ADDENDUM #3

Project : Layton City Commons Park Improvements, Project 22-05
(437 N. Wasatch Dr. – Layton, UT 84041)

Re: Request for Information

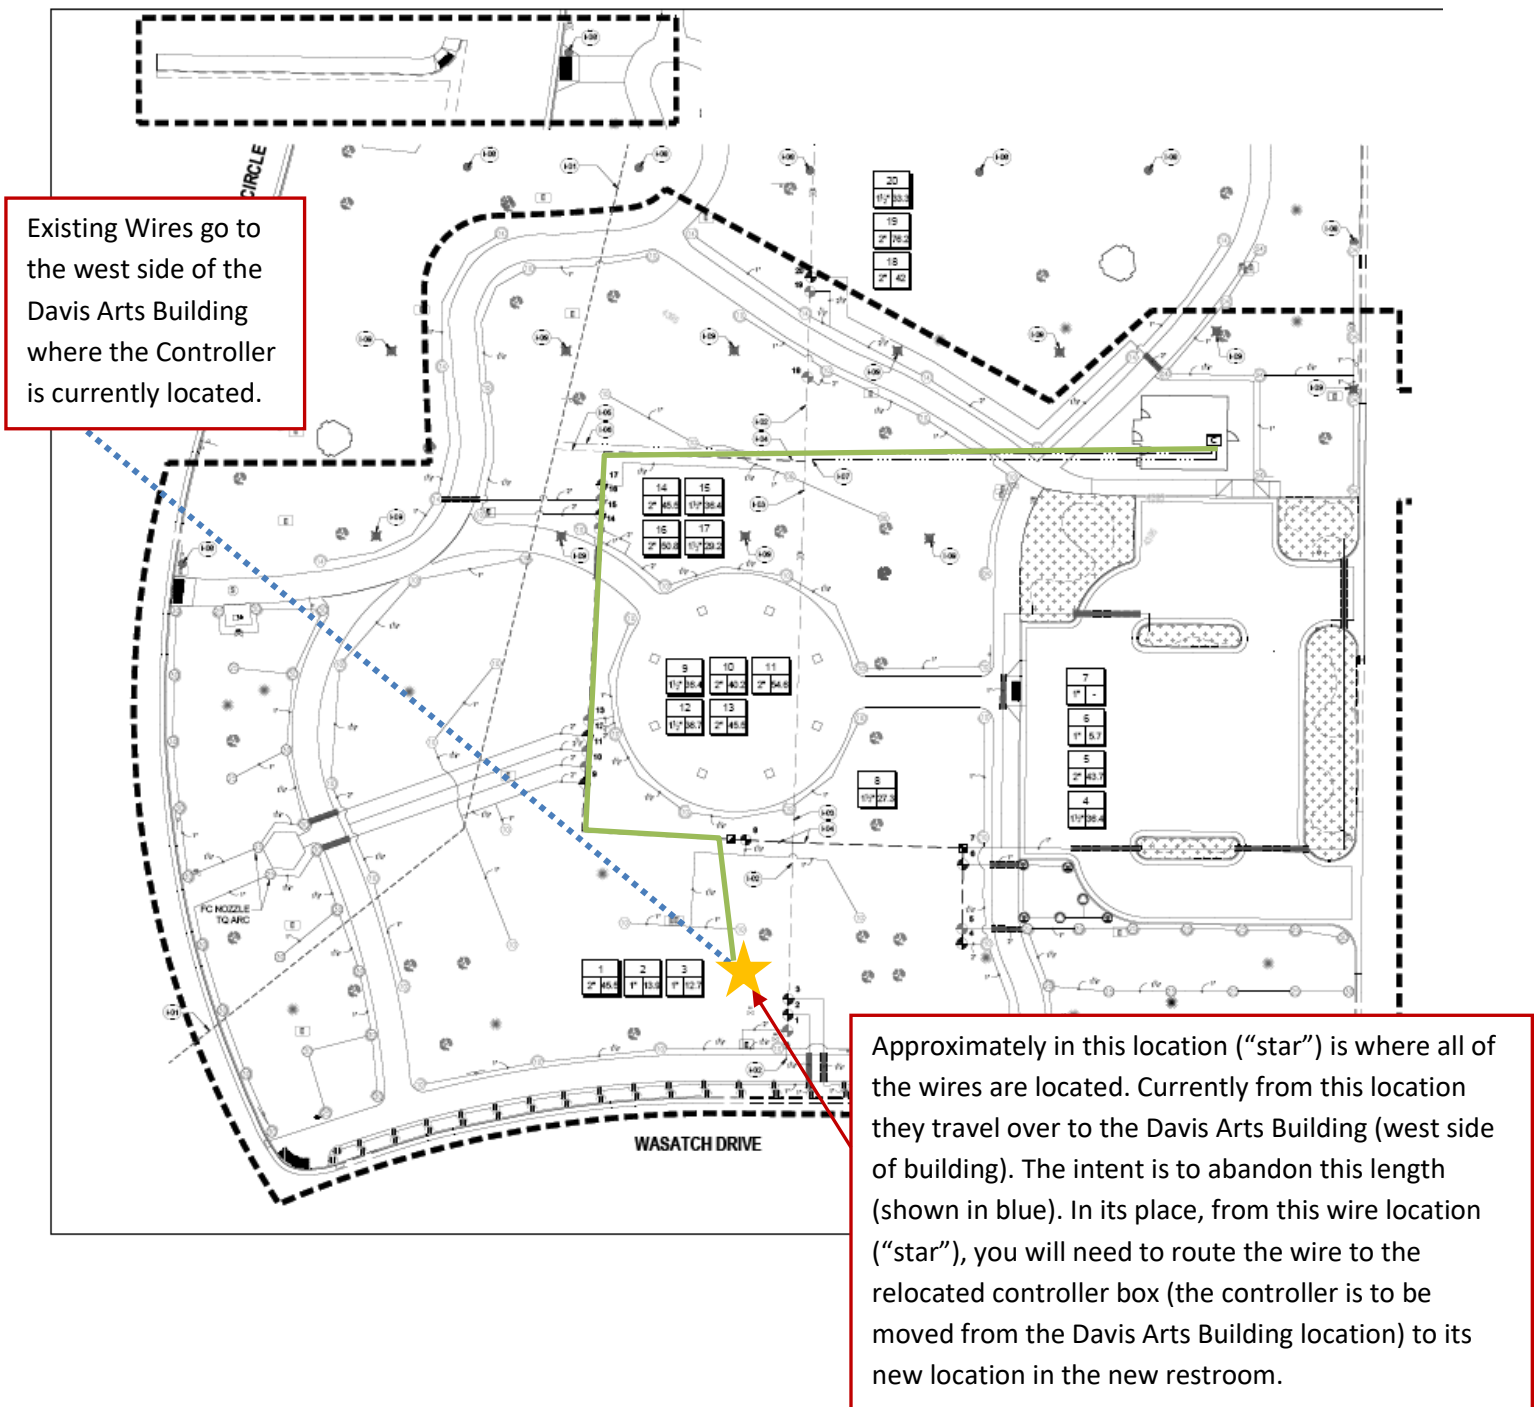
- b. Can we get a better as-built showing the existing valve boxes and a valve count showing what valves will need to be hooked up to the new clock location?

Please see the attached as-built map provided with better resolution. Most of the valve boxes are located along the original main line. The rescanned map has better clarity to note where those are located. All of the valves numbered will need to be hooked up to the new clock location.

1 ELECTRICAL SITE PLAN
SCALE: 1/32" = 1'-0"

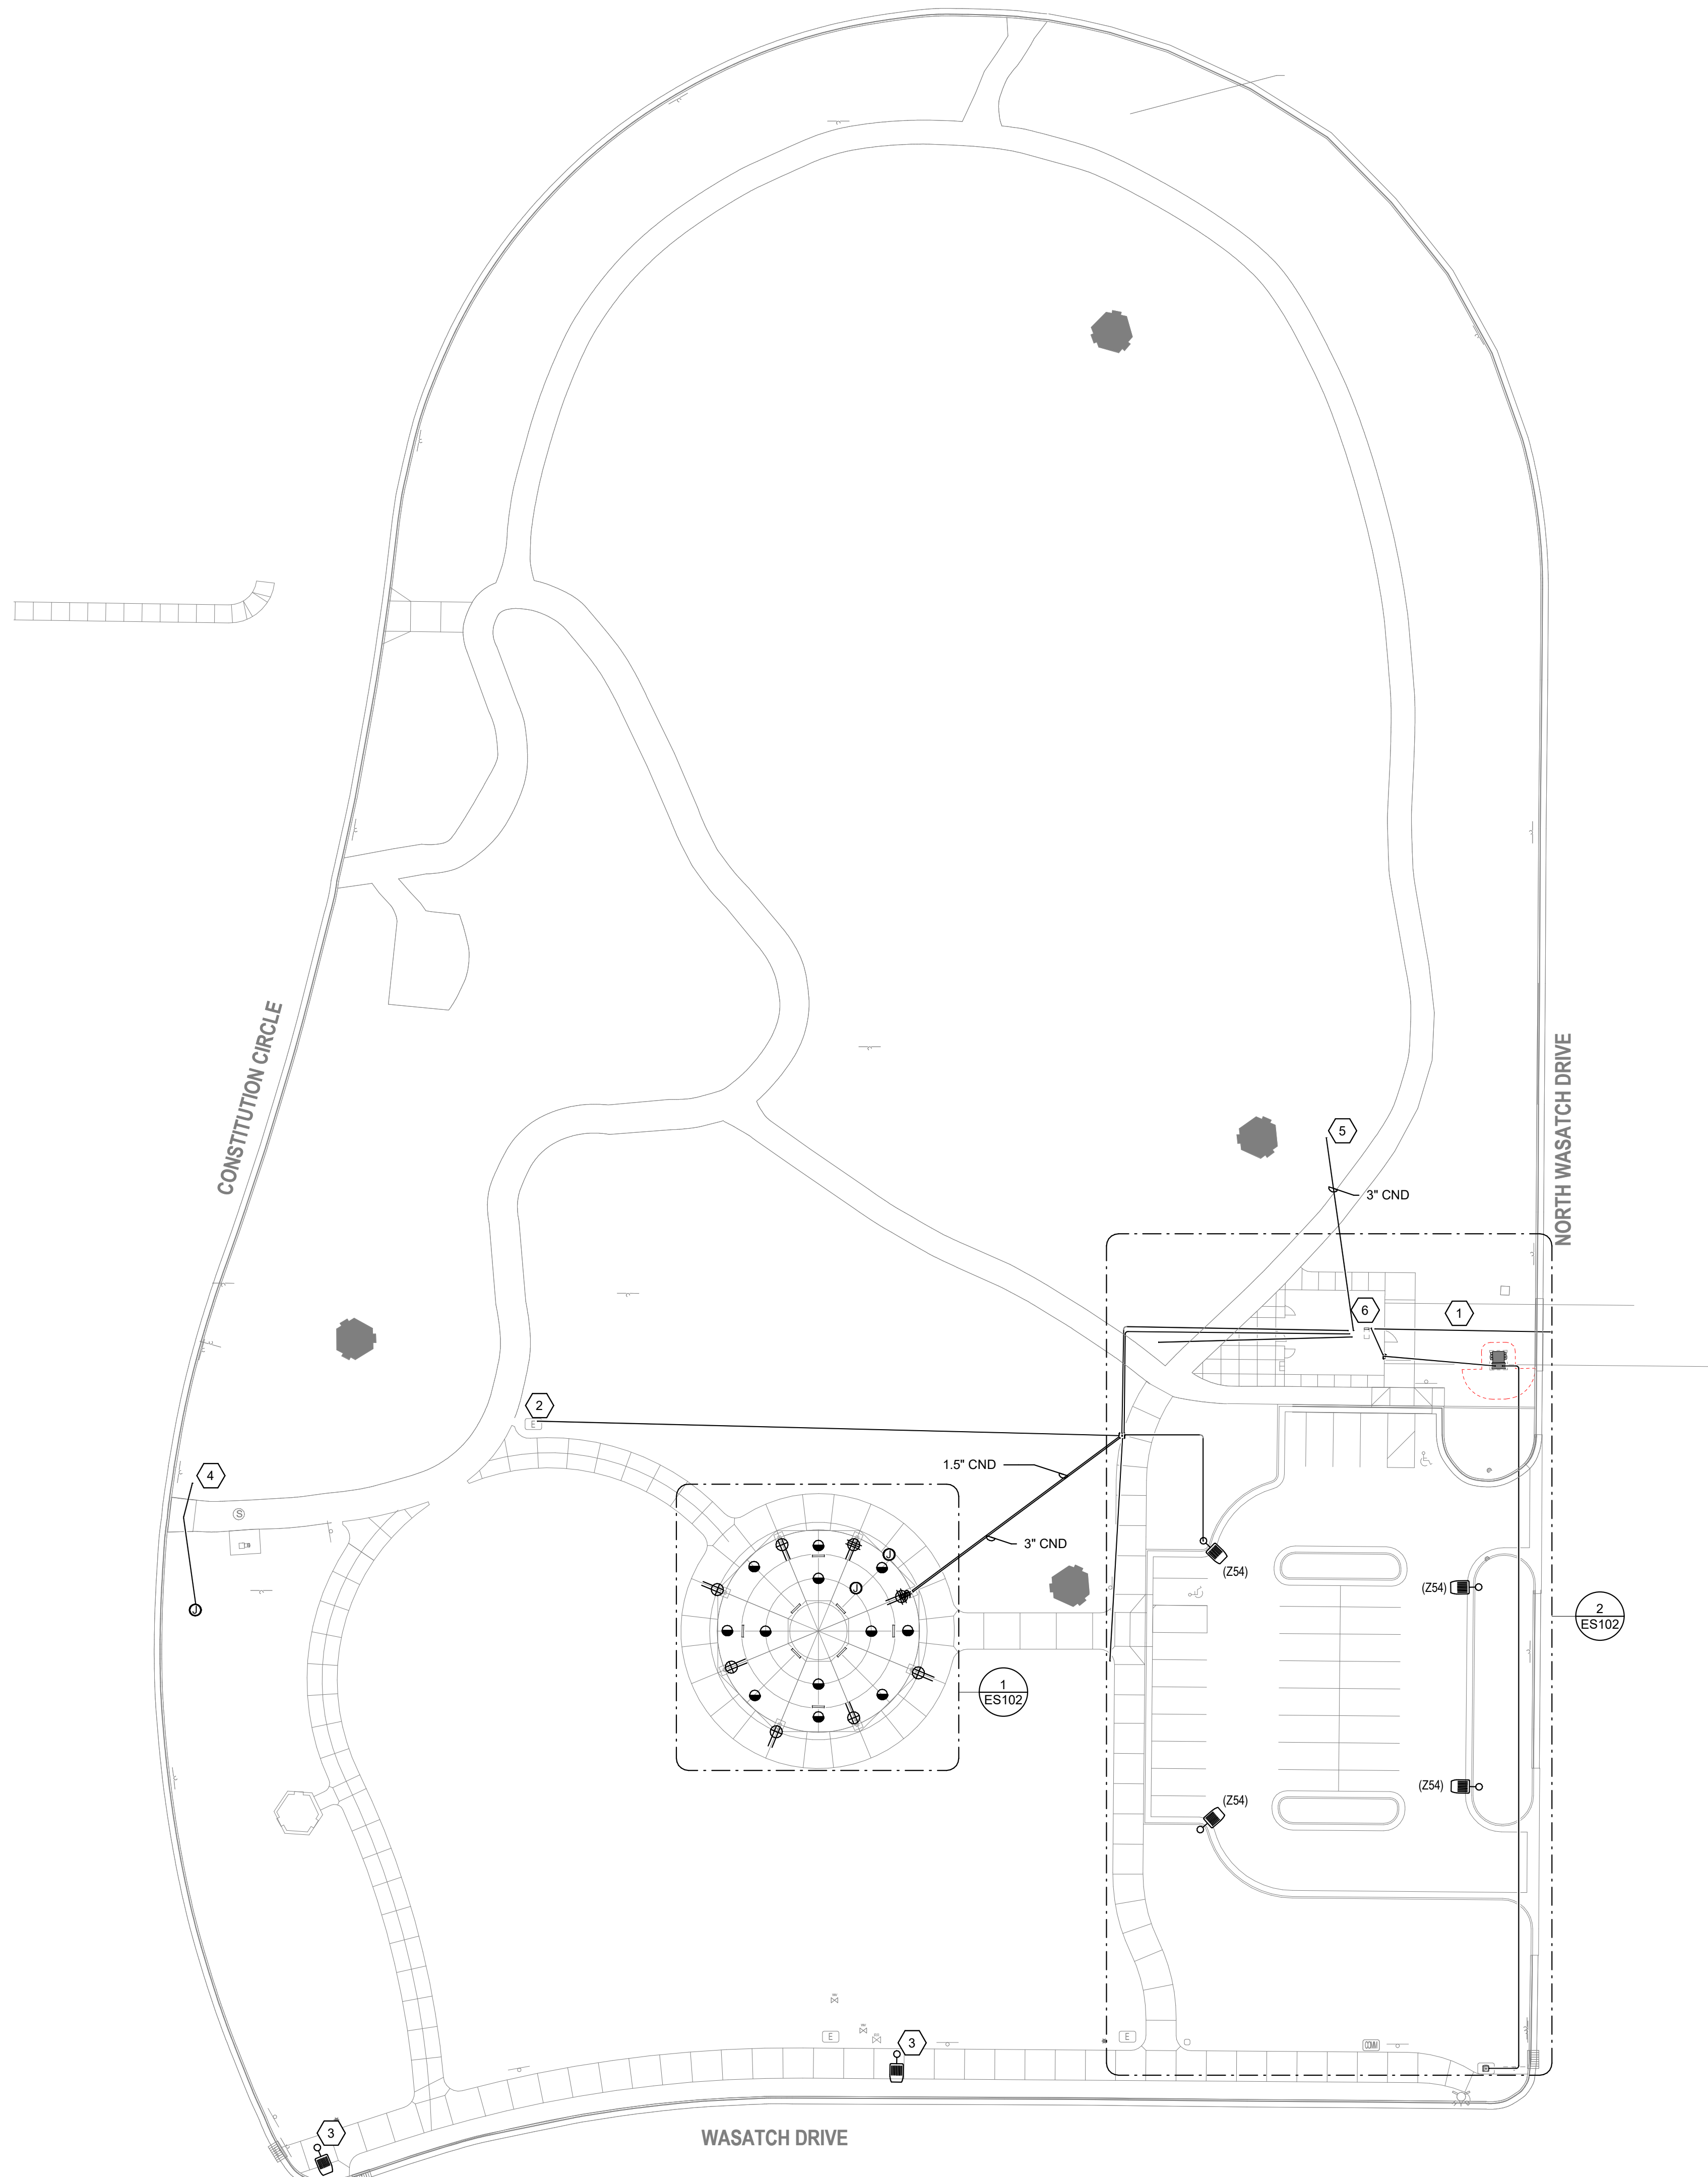
- c. Can we get a detail showing how to get wire back to the new clock location? Will the wire need to be in conduit and how are they to be installed/how deep?

d. Can we get a parts list of what needs to be added to the existing clock?

Please see the map below for how to get the existing wires to the new clock location. The wires are to be bundled and direct buried in the ground at 18" depth.

EXISTING WEATHERTRAK ETPRO3 W/NEW EXPANSION
RELOCATE FROM EXISTING LOCATION JUST EAST OF THE
DAVIS ARTS COUNCIL BUILDING. EXPAND 18 STATION TO
30 STATION CONTROLLER BY PROVIDING ADDITIONAL 24
STATION OUTPUT BOARD AND SUPPLEMENTAL 6-STATION
KEY. WIRE TO ALL NEW AND EXISTING ZONES TO REMAIN.

The existing controller is to be re-used. The station is to be expanded by providing an additional 24 station output board and supplemental 6-station key. Please reach out to Weathertrak for any additional details desired.
